GEORGE PROAKIS, DIRECTOR OF PLANNING LORI MASSA, SENIOR PLANNER DAN BARTMAN, SENIOR PLANNER AMIE HAYES, PLANNER MELISSA WOODS, PLANNER DAWN PEREIRA, ADMINISTRATIVE ASSISTANT **Case #:** ZBA 2013-08 **Date:** August 1, 2013

# **UPDATED PLANNING STAFF REPORT\***

**Site:** 47 Fairmount Ave

<u>Legal Notice</u>: Applicant, Richard Di Girolamo, and Owner, Edward Dolan, seek a Special Permit under SZO §4.4 to alter an existing 3-family dwelling to make alterations such as a second story front porch, expanded dormer, and window and door alterations. The Applicant seeks a Variance to build a third story with the construction of a dormer under SZO §5.5. RA Zone. Ward 7.

Existing (Pre-Construction) Southwest Elevation

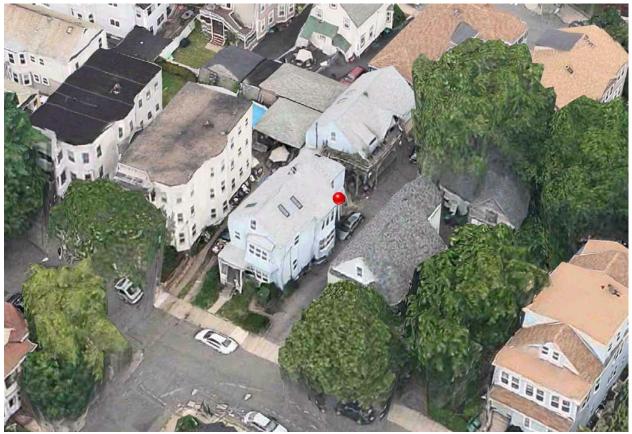
The dormer creates a third story and alters the form of the 2 ½ story house. It also decreases the visual privacy of residents at 43 Fairmount Street.

The new dormer adds two dimensional non-conformities to the site: the building height and floor area ratio. The building is now considered a 3 story because the dormer is greater than 50% of the length of the sloping roof to which it is attached. The definition of half story is in place to preserve the architectural fabric of the City that is comprised of a great deal of 2 ½ story houses. Constructing a dormer that is greater than 50% of the roof length makes the roof become over powered by the dormer and detracts from the original form and balance of the massing of the house.
